Docket Item # 13
BAR CASE #2008-0170

BAR Meeting
October 15, 2008

ISSUE: Signage
APPLICANT: TD Bank, NA
LOCATION: 119 South Washington Street
ZONE: CD/Commercial

Figure 2: Existing and proposed Washington Street signs

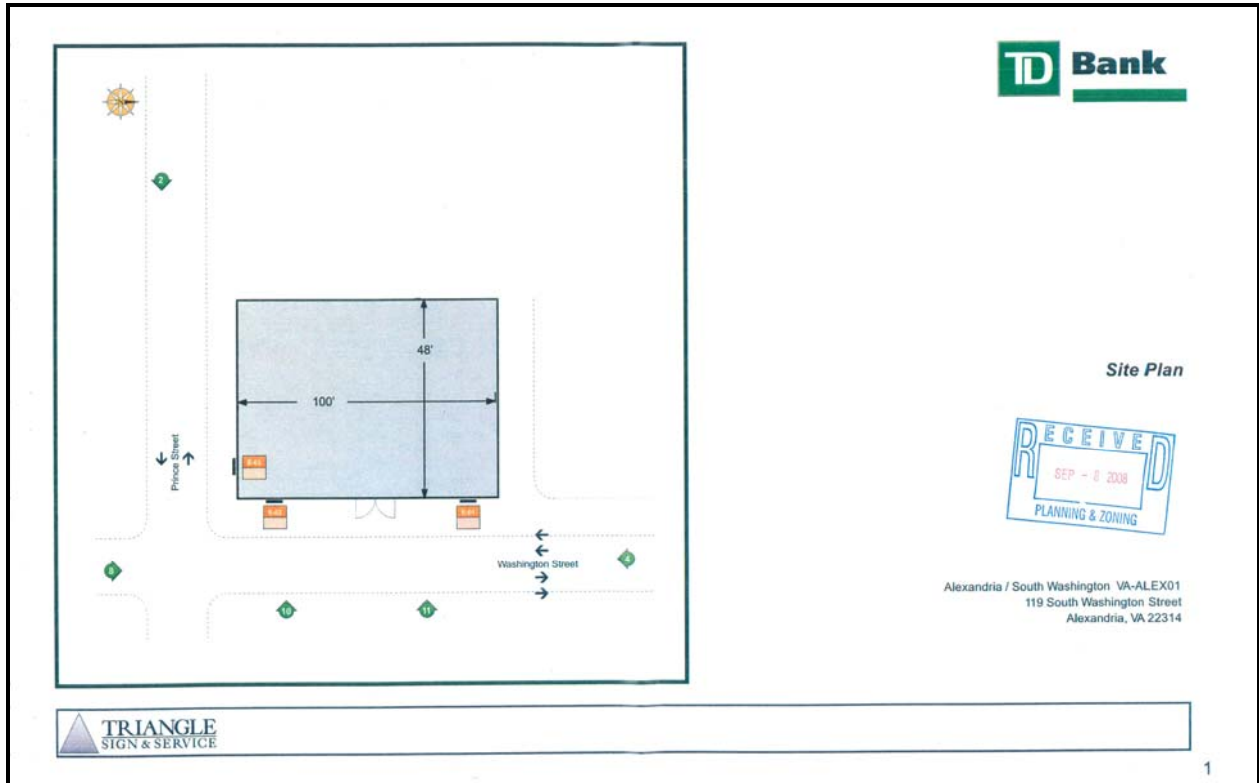
The application materials indicate that the proposed signs will be the same size as the existing signs. However, the measurements provided are larger than the existing signs. Staff believes that the proposed signs should be no larger than the existing signs, which are 9.5’ in length along Washington Street and 7.5’ in length on the Prince Street elevation (the height of the existing and proposed signs is the same).

When the existing Commerce Bank signs were approved in 2005, Staff supported the applicant’s proposal to use a matte brass plaque as a backer for the sign components because it minimized the number of penetrations into the limestone facade. In addition, the matte brass plaque helped to relate the otherwise modern looking signage to the Art Deco style building. Staff does not believe that the proposed aluminum box is the most appropriate material for the new signs and would prefer to see the applicant use a backing similar to the one installed for the Commerce Bank signs, including a beveled edge.

1. That the proposed signs not be illuminated;
2. That the aluminum box on which the new TD Bank signage is mounted is changed to a matte brass plaque similar to the sign backing previously approved and currently installed for Commerce Bank;
3. That the new sign backing have a beveled edge similar to the existing Commerce Bank sign;
4. That the applicant return to the Board with any proposed signage for the Prince Street doors; and
5. That the new signs are no larger than the existing Commerce Bank signs.

Figure 3: Existing and proposed Prince Street sign

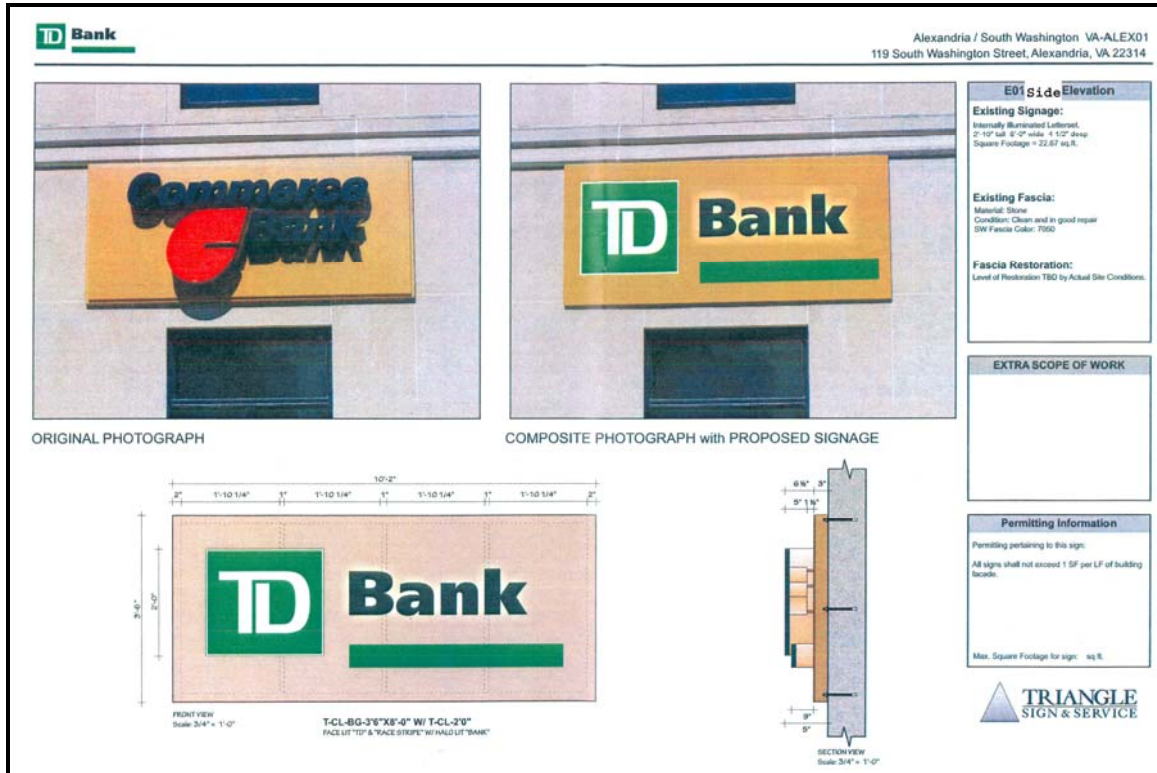
The submitted drawings show that the Prince Street door will have clear glass providing views into the bank. What currently exists is a completely opaqued door with a small area of signage identifying Commerce Bank. Staff can only assume based on the drawings that the existing signage and opaque film will be removed. The applicant should be aware that should new signage be proposed for this location it will need to be reviewed and approved by the Board.

Figure 6: Sign section

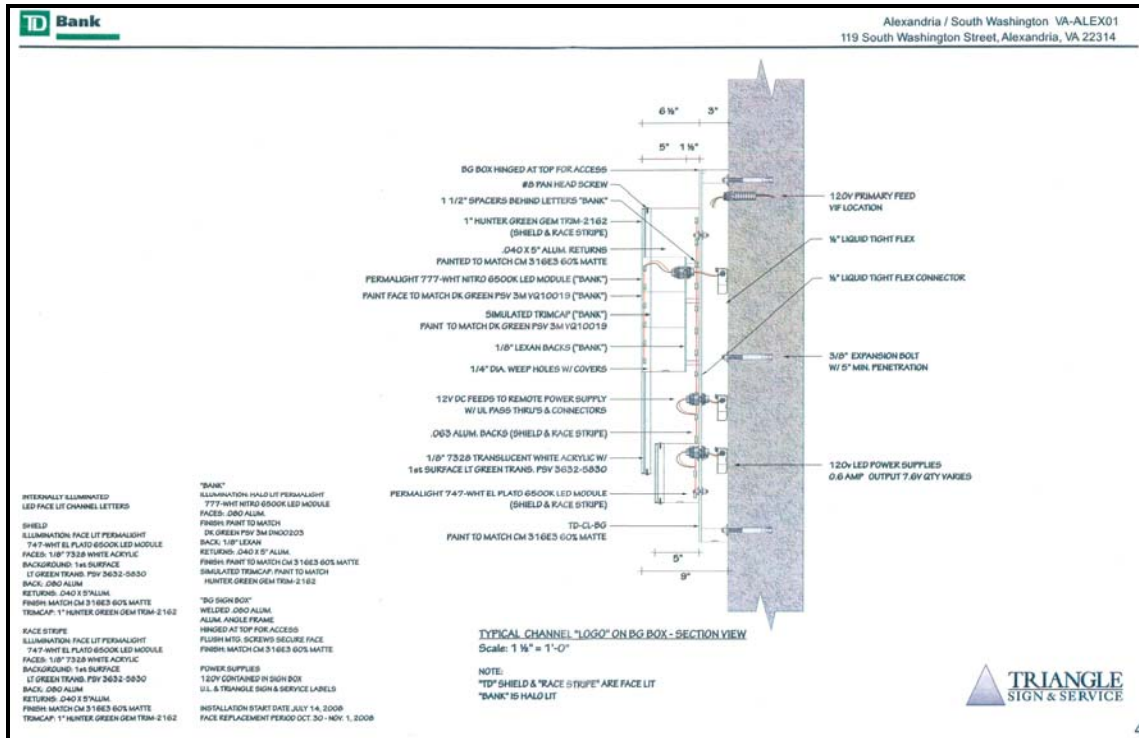
C-2 Wall letters / signs must comply with USBC [H103-H111] Please indicate the method to be used for anchoring the letters to the wall.

Figure 7: LED layout for Prince Street sign

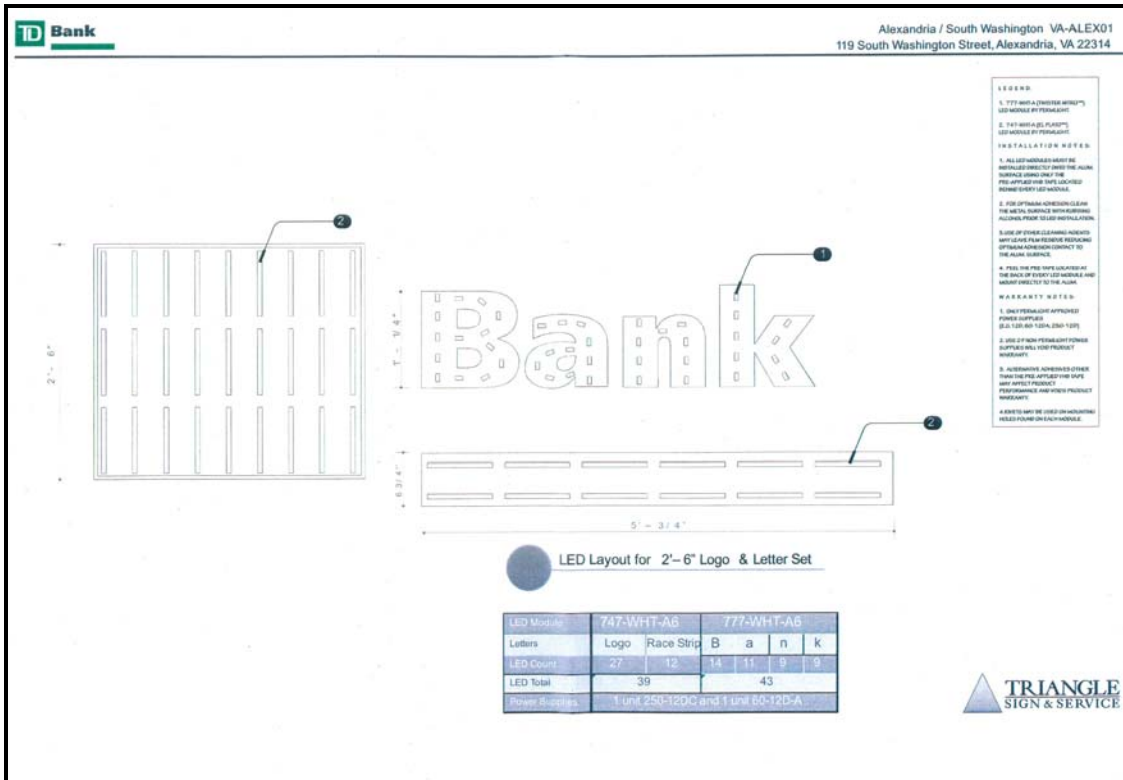
Staff finds the proposed illumination – both through internal illumination and halo lighting – to be inappropriate for this important historic building, especially given its location along the George Washington Memorial Parkway. The *Design Guidelines* specifically state that “The Board is particularly concerned with the maintenance and memorial character of the George Washington Memorial Parkway which passes through Alexandria as Washington Street. Therefore, requests for signage on Washington Street must be compatible with the memorial nature of the parkway.” In addition, the *Guidelines* specifically discourage the use of internally illuminated signs. Staff recommends that the proposed lighting of the TD BANK sign be deleted. While Staff would prefer to see the signs not illuminated in any way, Staff could support a more subtle form of lighting such as gooseneck lights mounted above the signs.

C-3 Electrical plans shall accompany the permit application that fully details the signage as well as layouts and schematics of the electrical system.
